PCN-20210608 CR00140-02 Kit SoM Update

Company	Trenz Electronic GmbH
PCN Number	PCN-20210608
Title	CR00140-02 Kit SoM Update
Subject	BOM change
Issue Date	2021-08-05

This change affects Trenz Electronic motor kit CR00140 of revision 02:

(#1) U6 at bottom side of TE0820-04-2AE21MA:

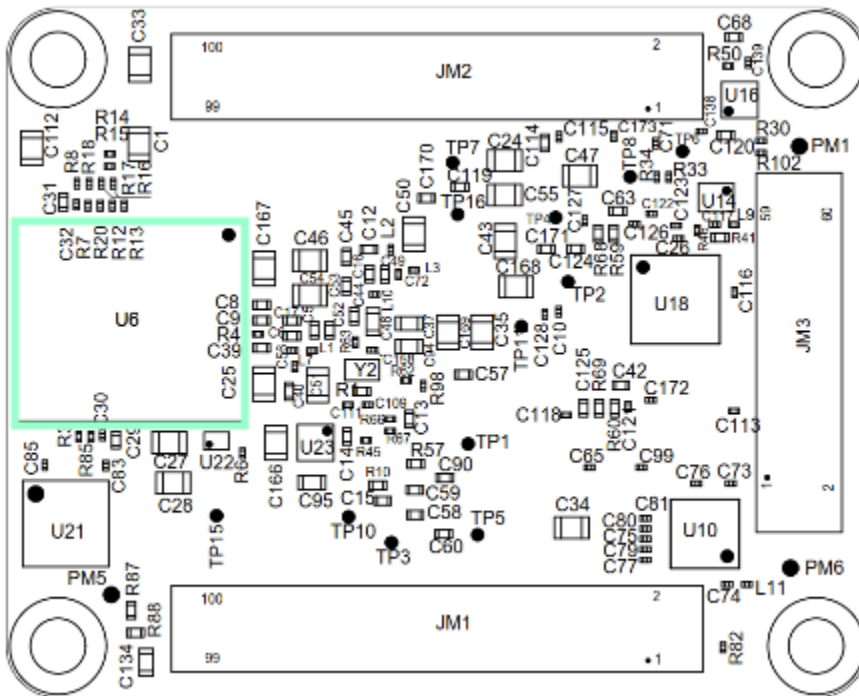
Locate eMMC at PCB, see chip markings below.

(#2) U15 at top side of TE0720-03-61C33MA:

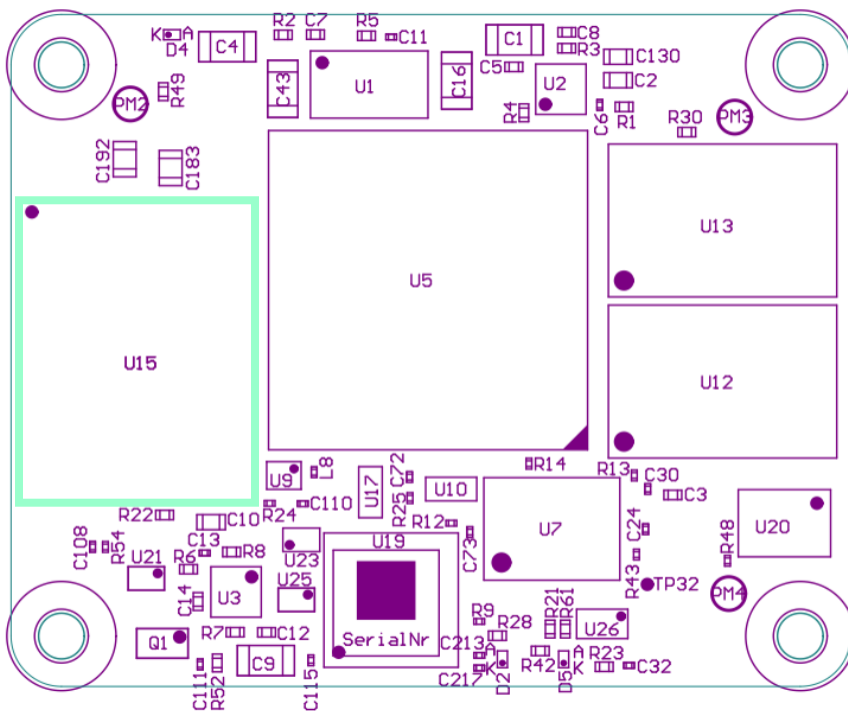
old	new
IS21ES08G-JCLI	SDINBDG4-8G-XI2
